## PREAMBLE TO AMENDMENT TO MOTOR VEHICLE SAFETY STANDARD NO.201

### Occupant Protection in Interior Impact—Passenger Cars

## PREAMBLE TO AMENDMENTS TO MOTOR VEHICLE SAFETY STANDARDS NO. 201

### Occupant Protection in Interior Impact

**Figure 1—Test Fixture for Clamped Specimens**

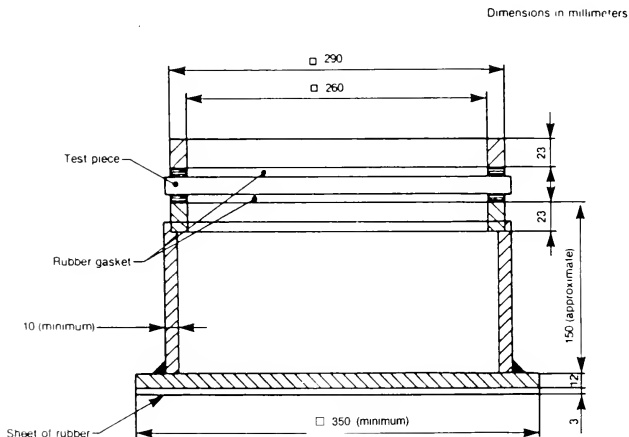
Paragraph (e) is added after paragraph (d) of S5.1.2.4 as follows:

Figure 1 is added at the end of Federal Motor Vehicle Safety Standard No. 205.

(e) The glass-plastic glazing specimen tested in accordance with Test No. 26 shall be clamped in the test fixture in Figure 1 of this standard in the manner shown in that figure. The clamping gasket shall be made of rubber 3 millimeters (mm) thick of hardness 50 IRHD (International Rubber Hardness Degrees), plus or minus five degrees. Movement of the test specimen, measured after the test, shall not exceed 2 mm at any point along the inside periphery of the fixture. Movement of the test specimen beyond the 2 mm limit shall be considered an incomplete test, not a test failure. A specimen used in such an incomplete test shall not be retested.

Figure 4—USE OF CLEARANCE TEST BLOCK TO DETERMINE HAND/ARM ACCESS

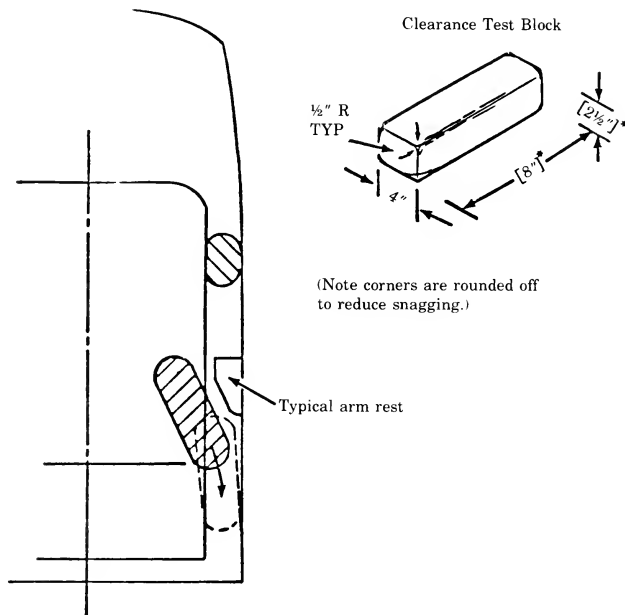
13. Figure 4 of this standard is modified as follows:
